North-South Project

Written comments received during the initial public comment period from October 8, 2015 to November 23, 2015

FIGURE 1
PROJECT OVERVIEW
NORTH-SOUTH PROJECT

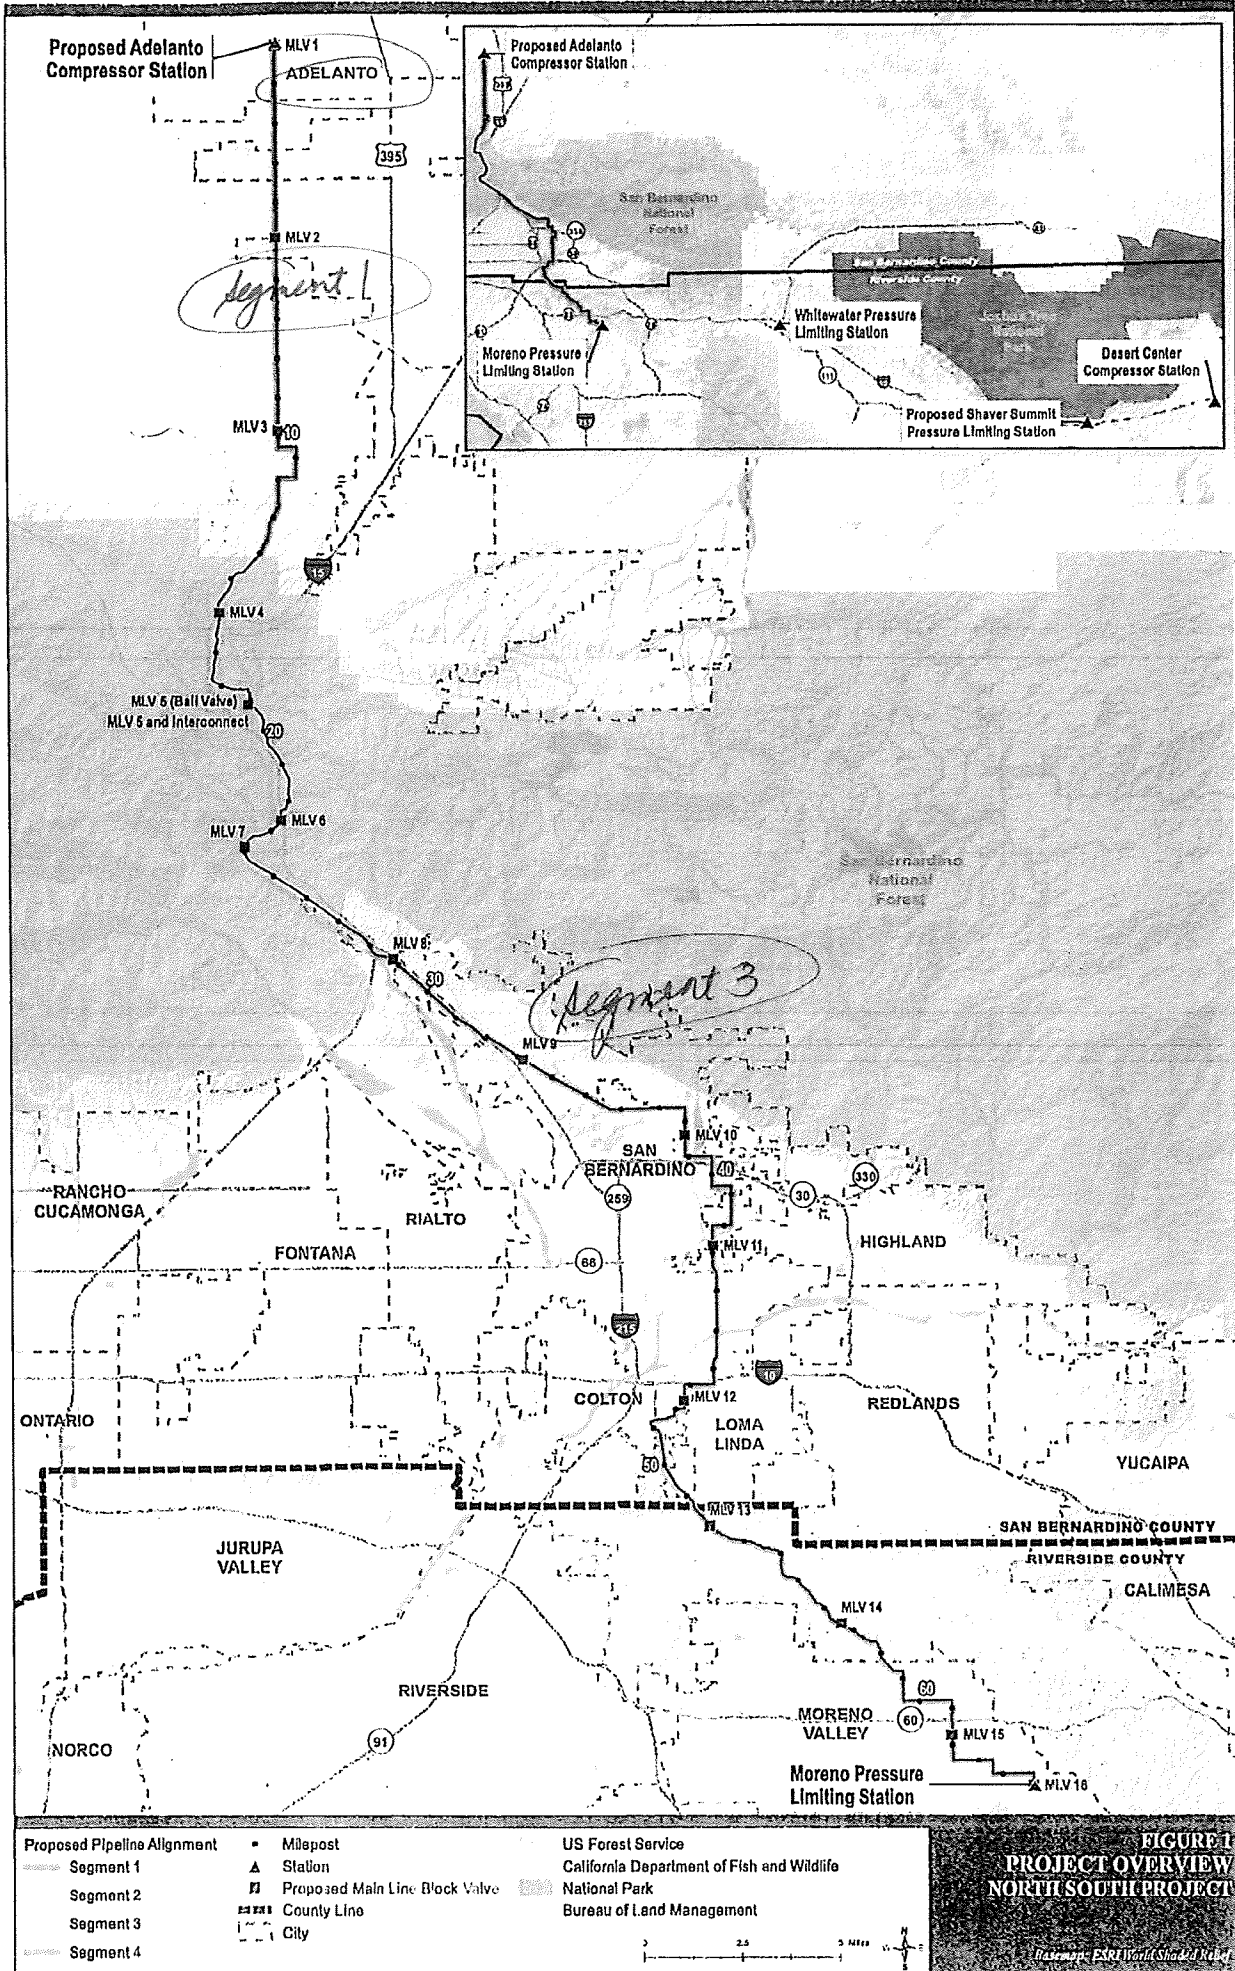
1. The project route as shown in Figure 1 of the draft report would subject potential impacts to the crossing of approximately 16 District Facilities within Zones 2,3 and 4 during the construction phase.

FIGURE 4

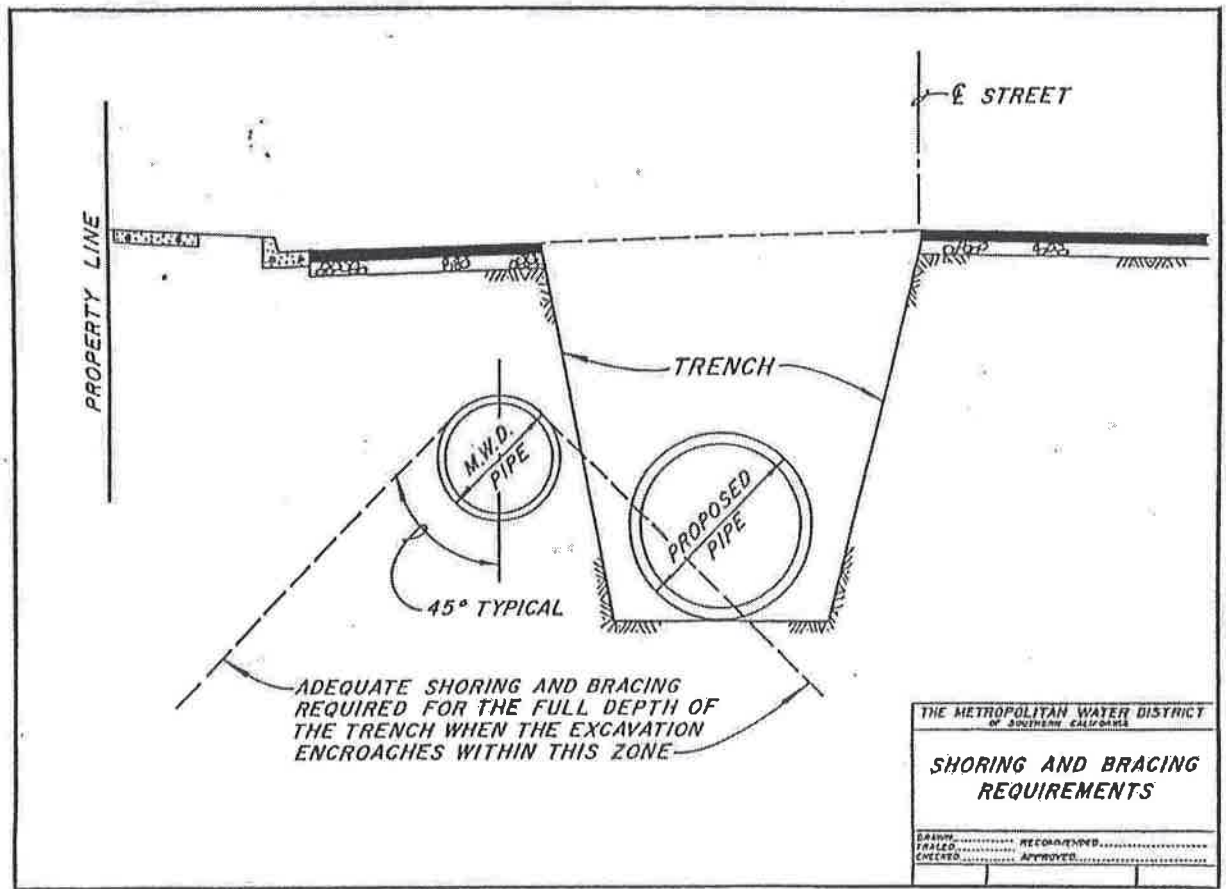
k. Adequate shoring and bracing is required for the full depth of the trench when the excavation encroaches within the zone shown on Figure 4.

Figure 1

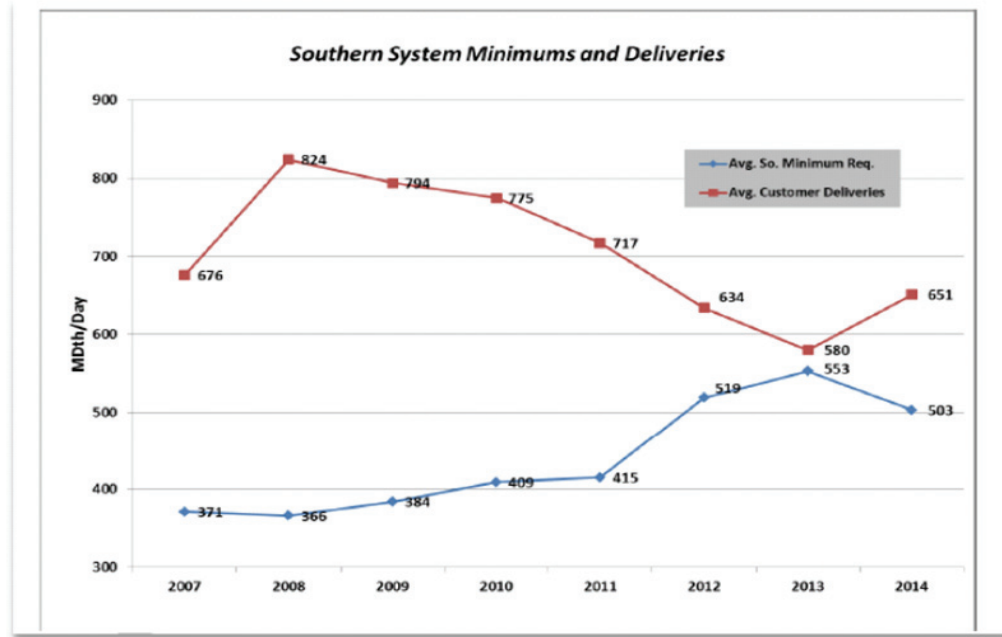
In a data request, SCGC requested the Applicants to update witness Marelli's Figure 1, which witness Marelli claimed to show a reduction in customer deliveries into the Southern System. When the Figure 1 was updated, it showed that there was a clear reversal of trends in 2014:¹²⁰

Figure 1 shows that while there was a decline in customer deliveries into the Southern System in the years 2008 through 2013, customer deliveries into the Southern System increased 71 Mdt/d, more than 12 percent, in calendar year 2014 in comparison to calendar year 2013.

Figure 3

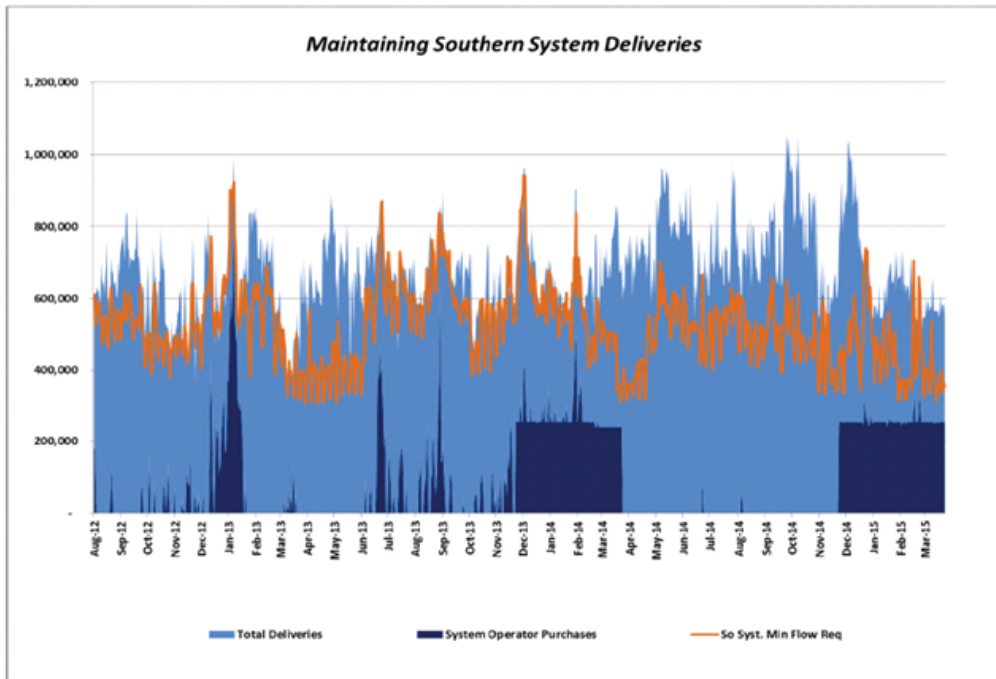
As a result of the coincidental decrease in the Southern System minimum flow requirement and increase in deliveries into the Southern System at Ehrenberg, flows into the Southern System in 2014 consistently exceeded, often by a dramatic margin, the Southern System minimum flow requirement, as shown by the following update of the Figure 3 that Ms. Marelli presented in her testimony:¹²⁶

The level of customer deliveries significantly exceeded minimum flow requirements nearly every day during the period, April 1 through November 30, 2014. The data for the 2014-2015 winter months showed lower levels of customer deliveries. However, despite the lower customer deliveries, deliveries through the MILC and baseload contracts in combination with customer deliveries exceed the minimum flow requirements a great majority of the time.
